ADDENDUM

Project:	COR Peach Road Center Renovation			Addendum # 02
Owner:	City of Raleigh			
Owner ID No.:	274-PR-PEACH 2023			
DKA Project No.:	2319			
Prepared By:	Jennifer Turner	Bid Documents Issue Date:	10.31.2023

Revision No. 001 City of Raleigh Comment Responses (Entire bid set issued to the City of Raleigh)

REVIEW COMMENTS & RESPONSES

D1 DEMOLITION FLOOR PLAN
1/8" = 1'-0"

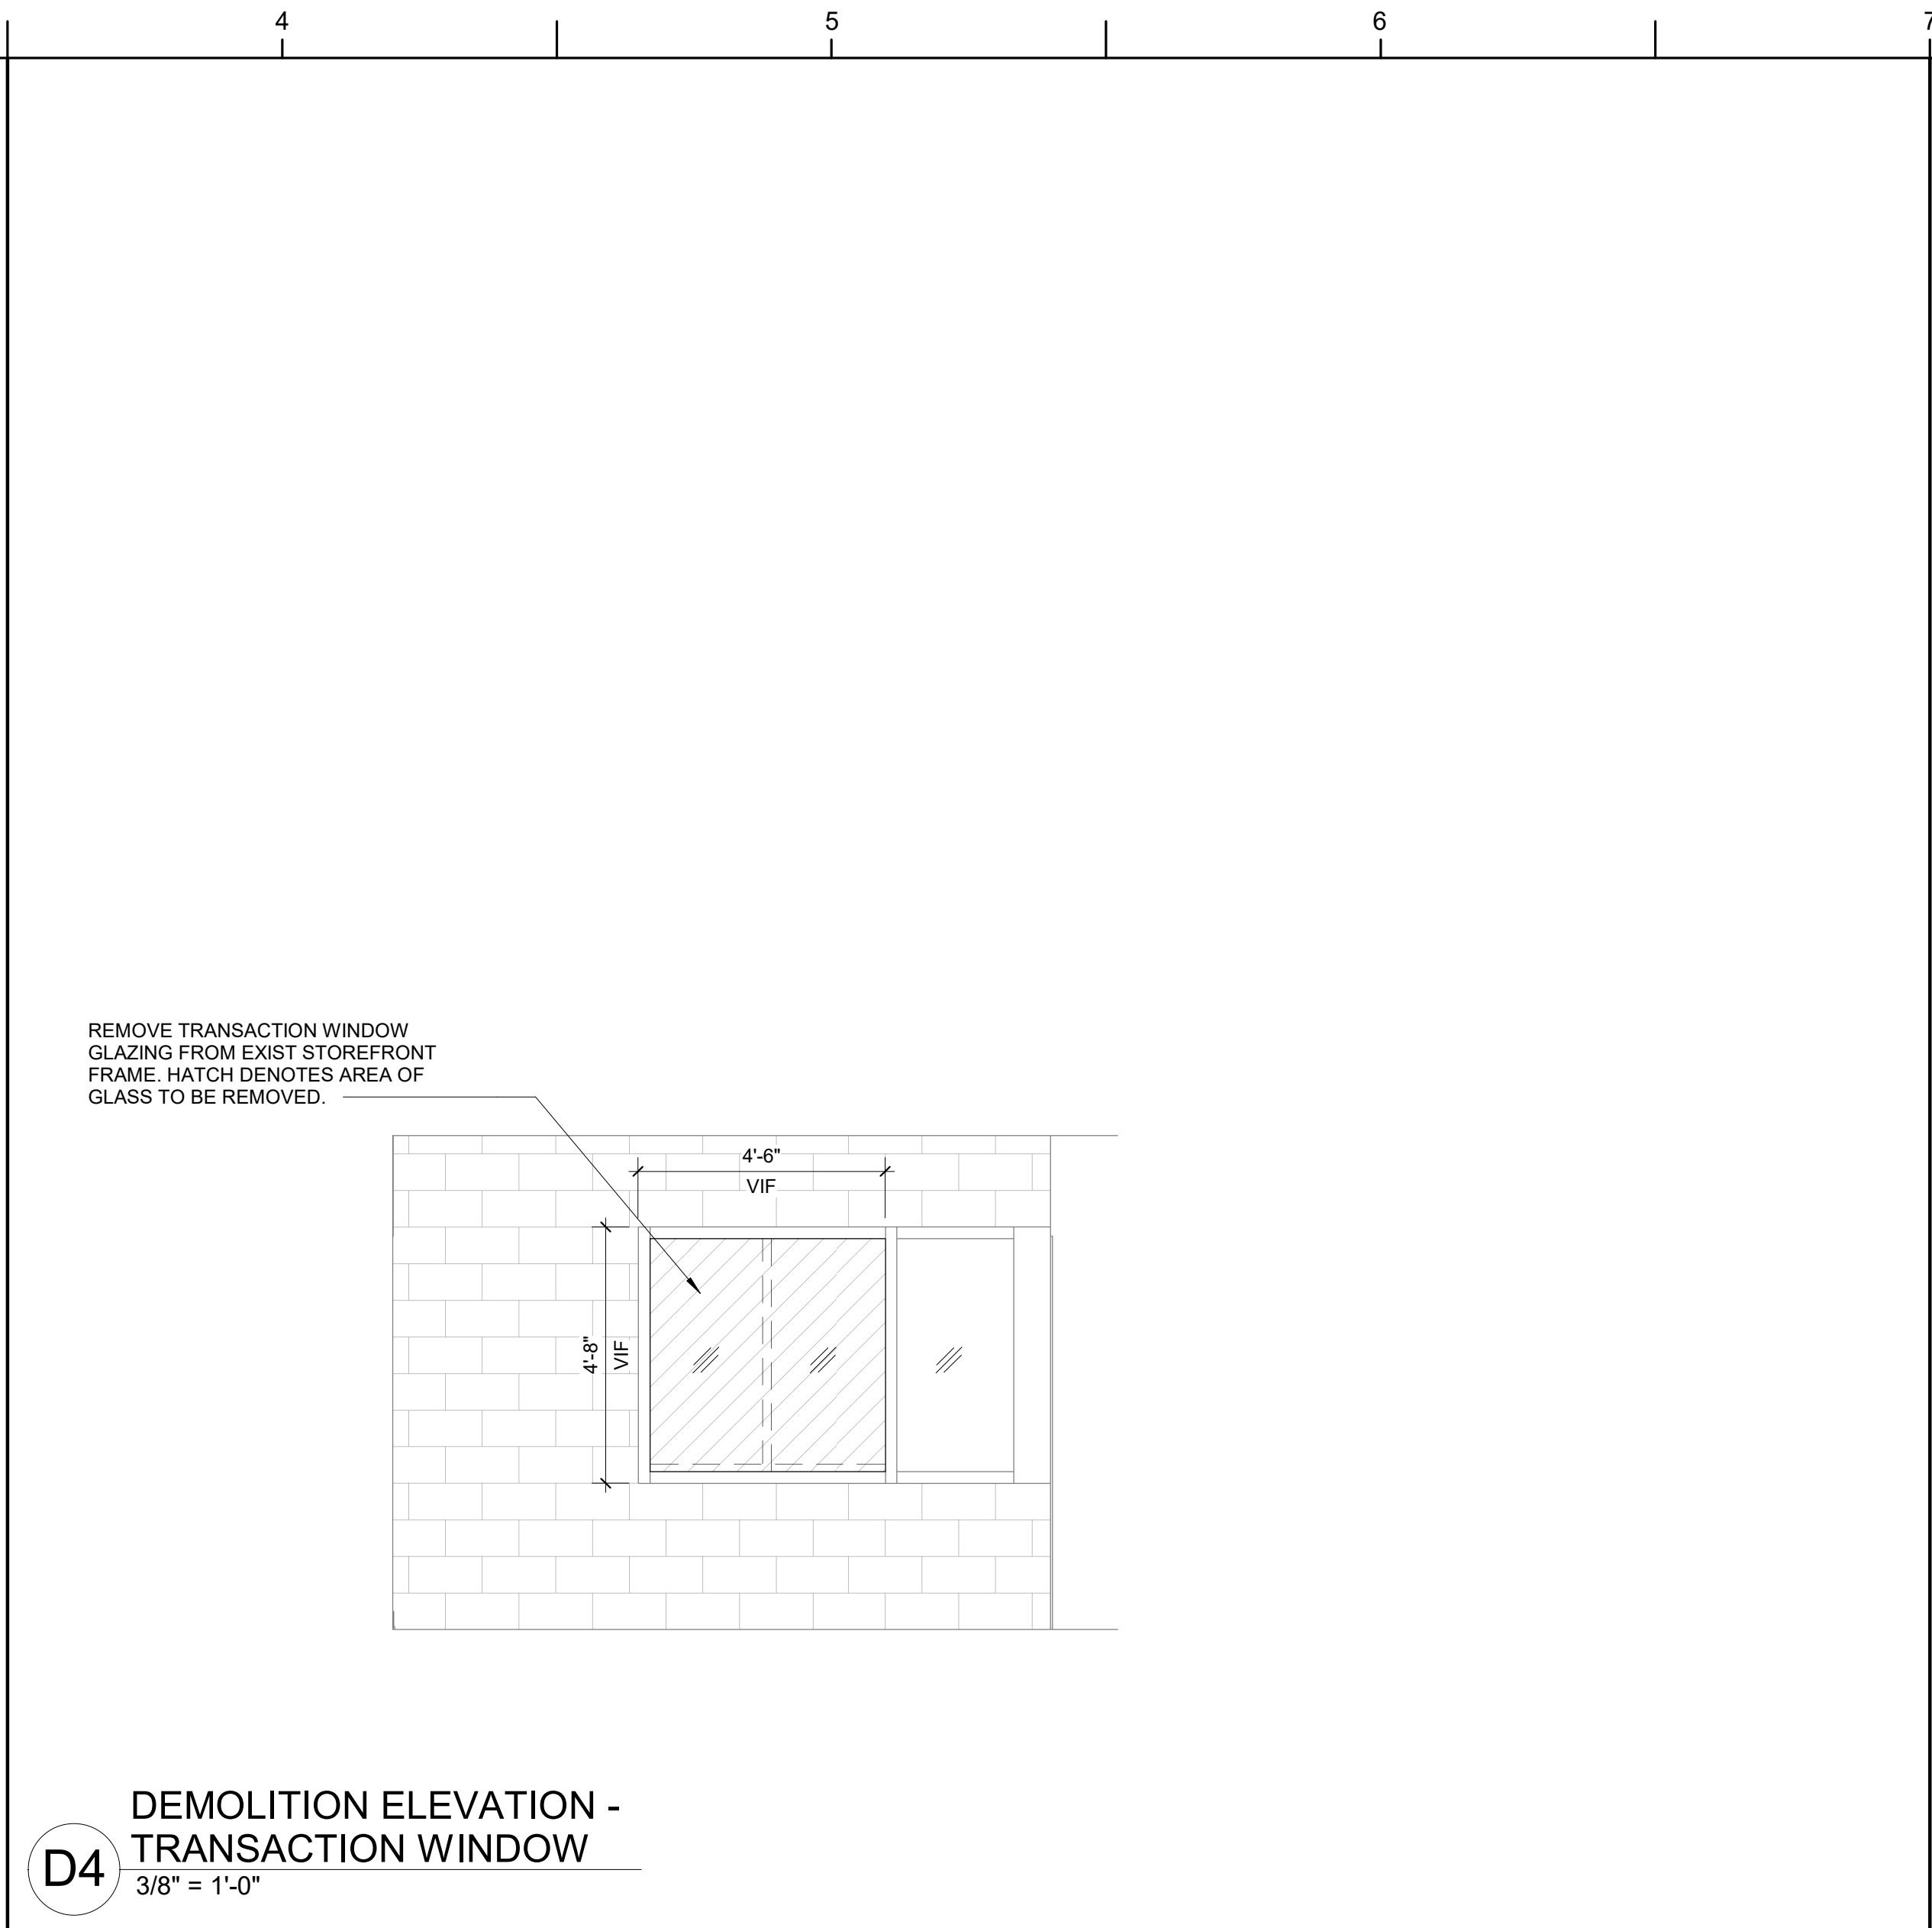
6. Demo plan D100, Demolition Plan Key Note #2 and Plumbing Plan P100, Plumbing Key Notes do not reflect the same thing. Demolition Note states to remove the toilets “carefully” and reinstalled. This is not stated on the Plumbing Key notes. Need clarification for Plumbing proposal.

- 1) Does this work fall on the GC or Plumbing Contractor?
 - a. This work falls under the General Contractor.
 - 2) If plumbing, a) Do the sinks and urinal in the restrooms need to come off the wall as well?

- b) What types of toilets are they (wall hung (brand name) or floor mounted?
 - a. The toilets are wall hung, Refer to Revision No. 001 City of Raleigh Comments Sheet, note “6” P1100 note “General contractor to remove existing plumbing fixture for new wall, floor, or casework finishes and reconnect to existing waste, water, and vent piping as required after finishes are completed.” This note refers to sinks and toilets.

E100

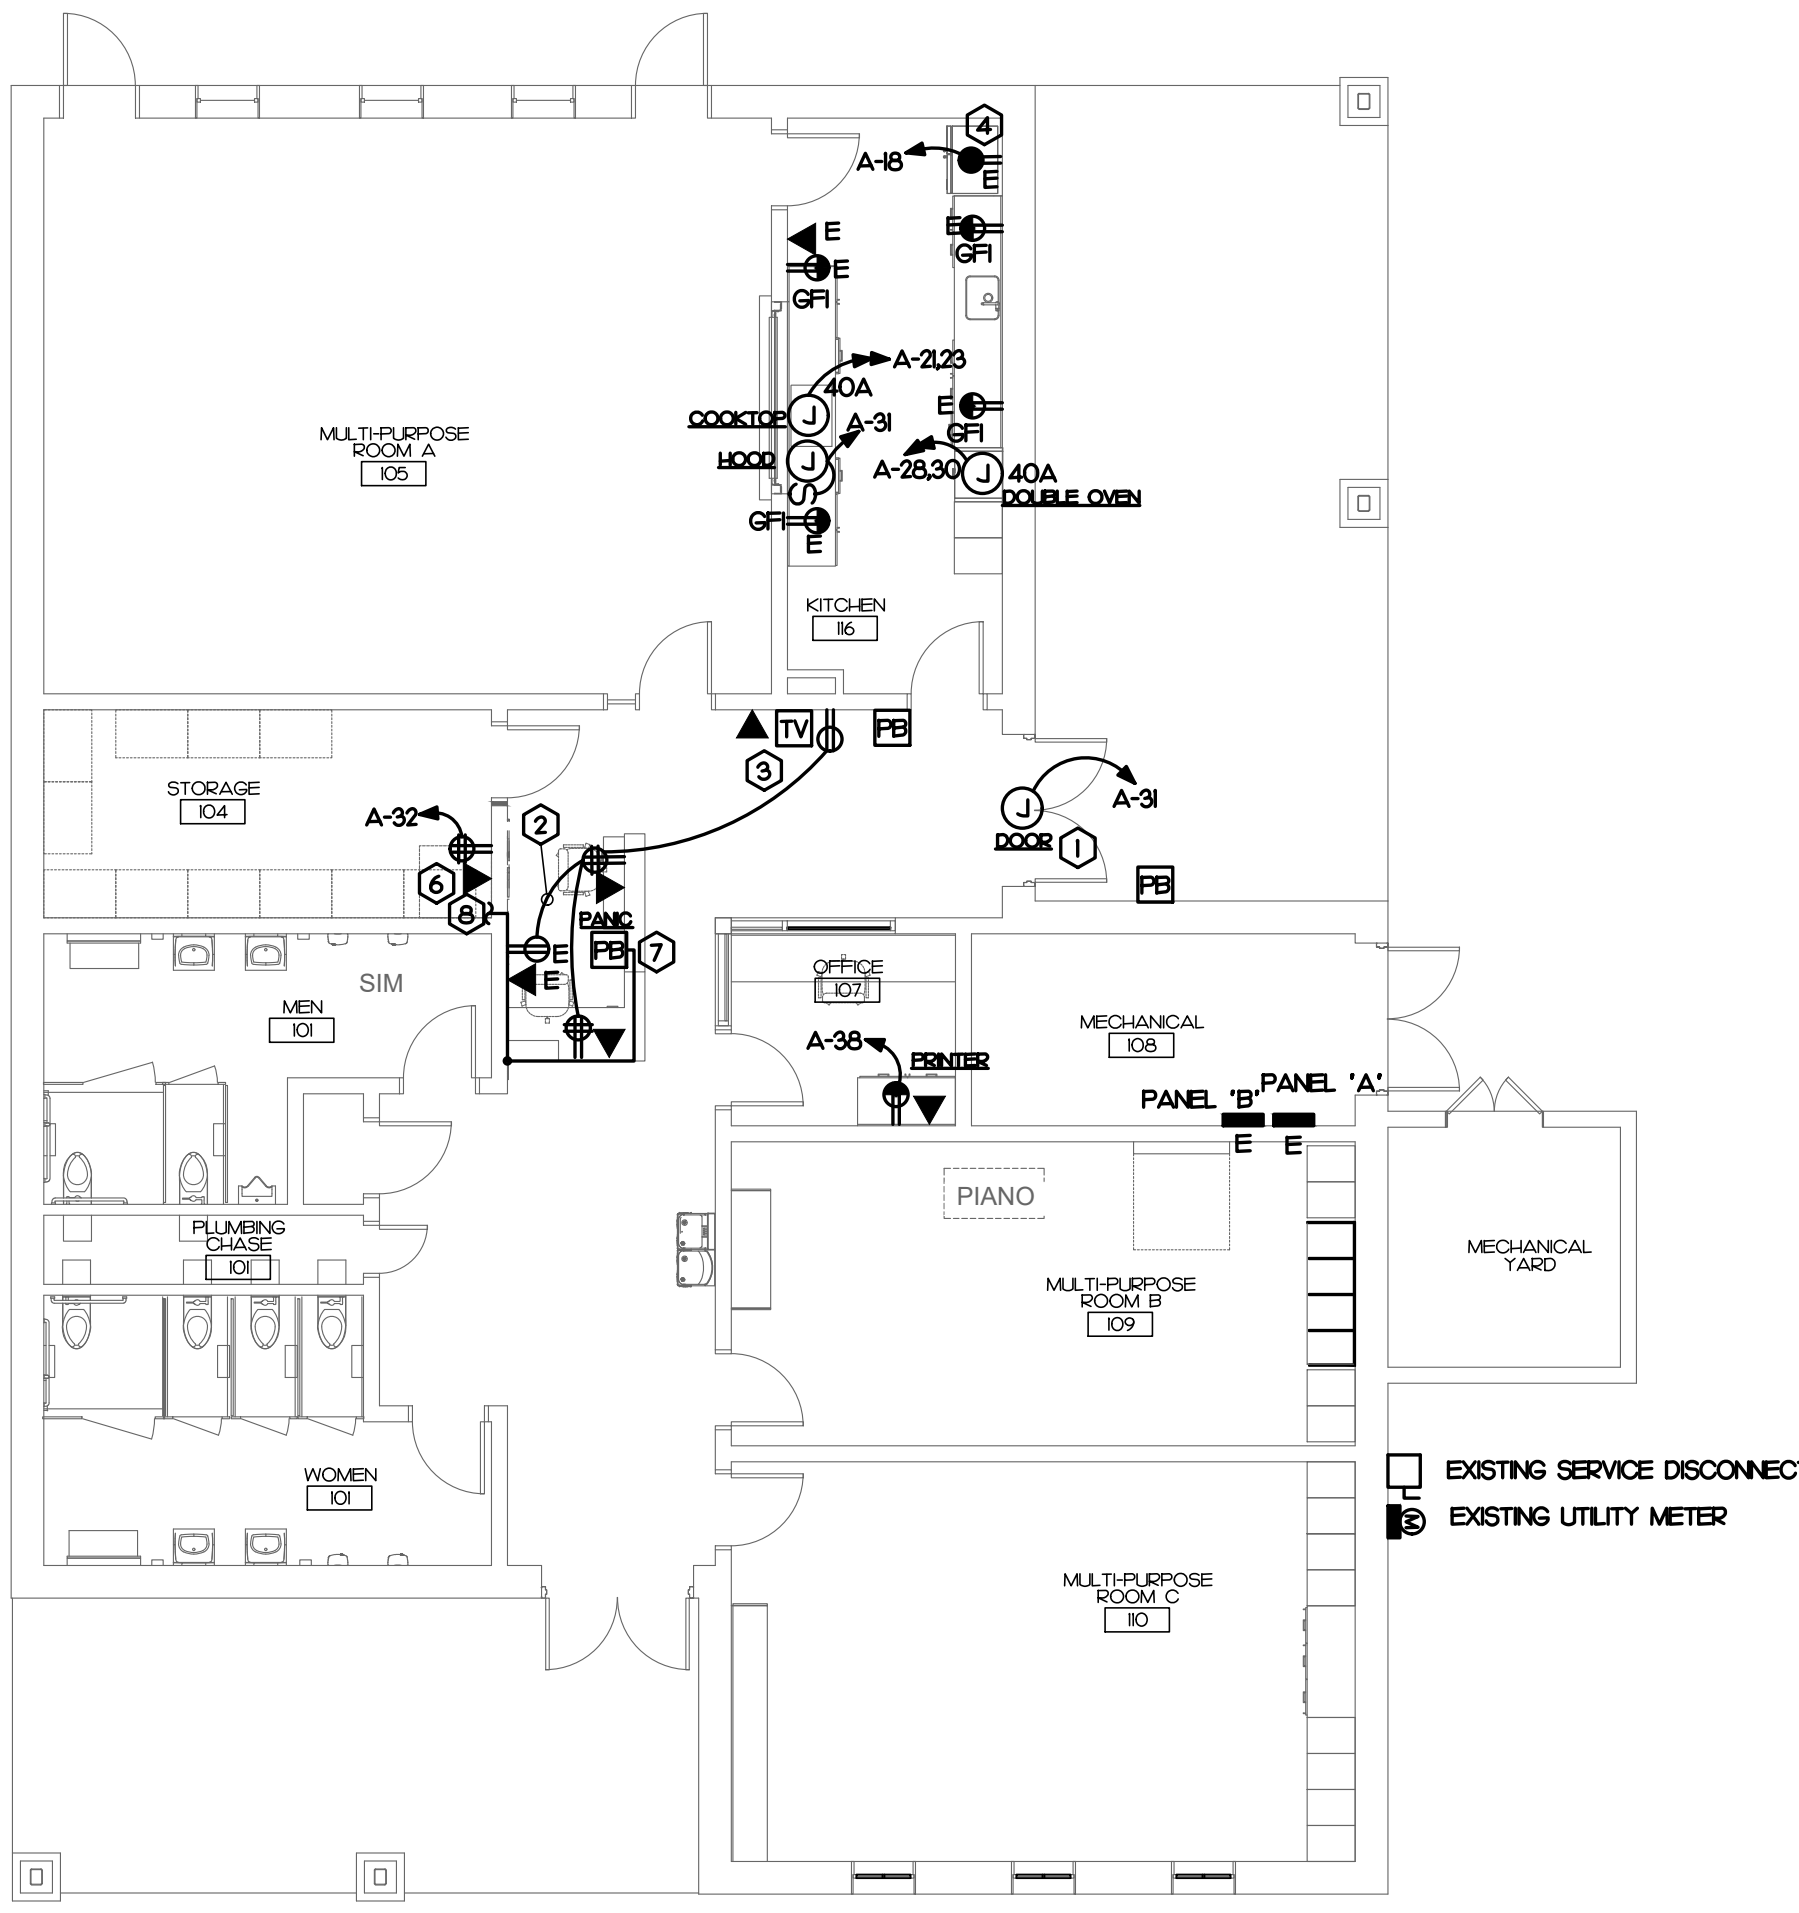
1. Can you verify if the electrical raceways can be surface mounted to the CMU and if EMT or Wiremold is required?
 - a. The conduit can be surface mounted and wire mold can be used on the existing CMU walls. Note on E100 calls for outlets and conduit to be surface mounted on the existing masonry walls.

NOTE:
1. OUTLETS AND CONDUIT ON EXISTING MASONRY WALLS TO BE SURFACE MOUNTED.
